Subject: Draft Revision 2 to Ice Condenser Utility Group Topical Report No. ICUG-001:
*Application of the Active Ice Mass Management Concept to the Ice Condenser
Ice Mass Technical Specification (TAC No. MB3379)*

***Application of the Active Ice Mass
Management Concept to the Ice
Condenser Ice Mass Technical
Specification***

Topical Report ICUG-001, Revision 2

Figure O-1. Ice Mass Surveillance Strategy

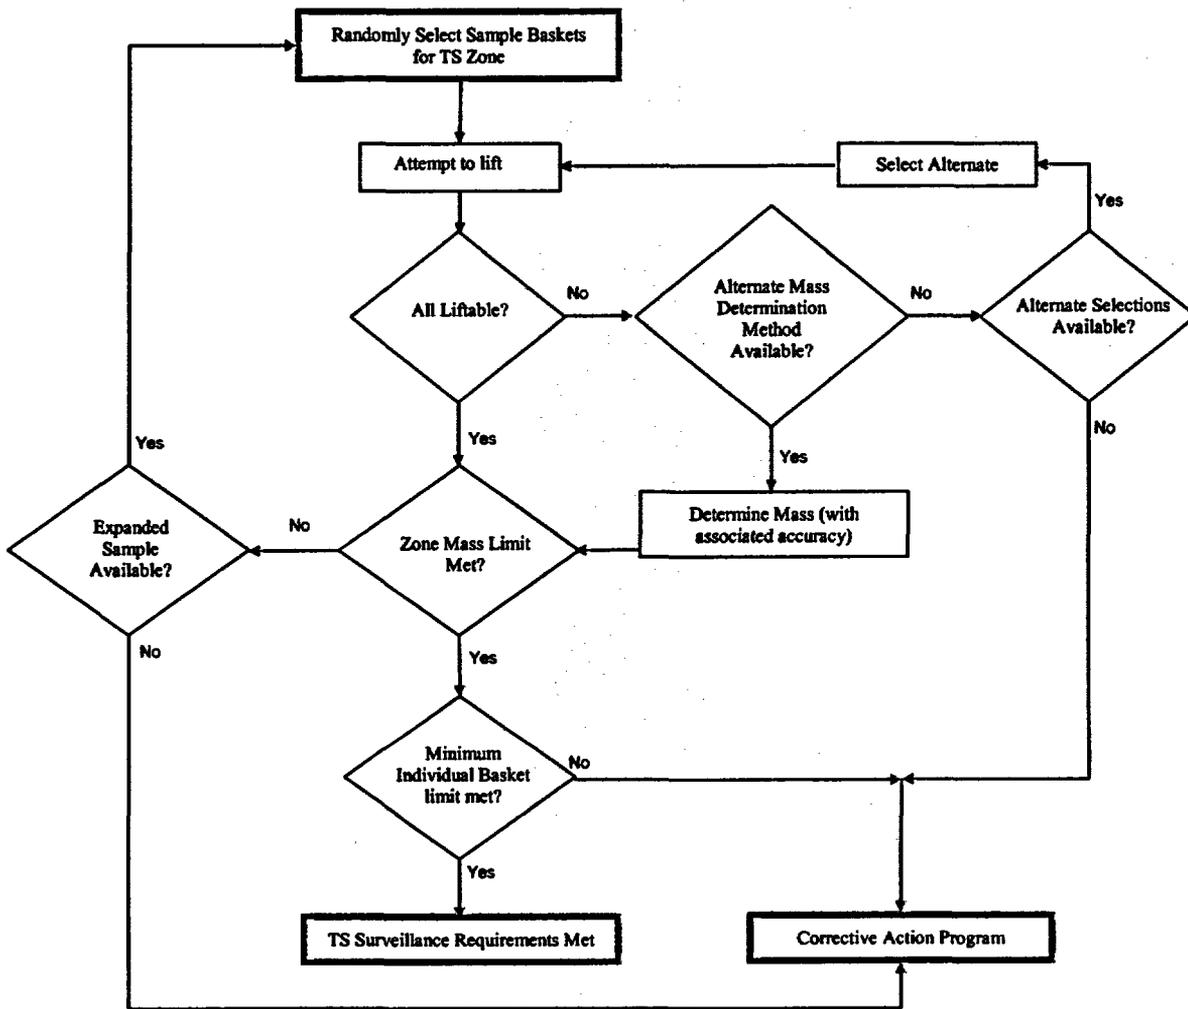
10. Page O-4, **Figure O-1**: Revised term in flow diagram "Blowdown Limit" to "Minimum Individual Basket Limit" per reference 22.
11. Page O-5, **Table O-1**: Revised fourth bullet to: "A surveillance for minimum total ice mass in the bed assures the initial conditions of the DBA analyses". Deleted fifth bullet. Revised sixth bullet to: "A surveillance for minimum ice mass in each individual basket prevents localized degradation to avoid any challenge to the DBA containment pressure response". Revised eighth bullet to: "Proper azimuthal distribution of ice in the ice bed is no longer assessed by a separate surveillance requirement; it is implemented through established industry-wide maintenance practices that manage each ice basket above the required safety analysis mean and confirmed through as-found random sampling techniques". Revised ninth bullet to: "All ice baskets in the parent population are subject to random statistical sampling, as opposed to only two-thirds of the population subject to representative sampling." Changes per references 22 and 27.

Figure 1-1. Typical Plan View of Containment Building

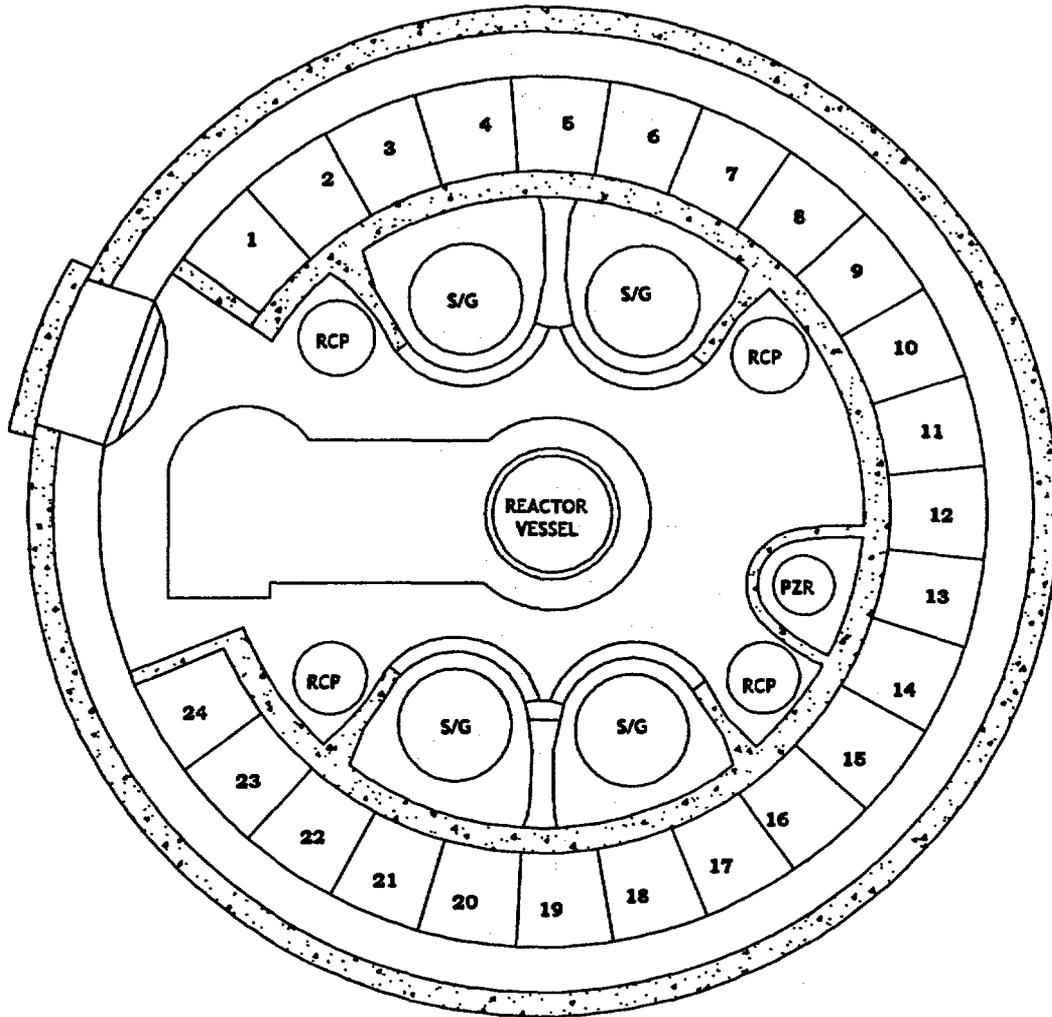
16. **Page I-3, Original Ice Mass Technical Specification Requirements:** Revised paragraph under Figure 1-1 to read: "In addition, these masses were used as the verification that a degraded localized region did not exist in the ice bed that would challenge the DBA pressure response. If a basket in the 144-basket statistical sample was found to weigh less than the required individual limit (described as "light"), the sample was to be increased in the localized region (i.e., the affected Bay) by 20 baskets. The averaged mass of the 20 additional baskets and the "light" basket was then required to meet the surveillance limit". Deleted reference to the long-term phase of the DBA in the last sentence on the page. Changes per references 22 and 27.
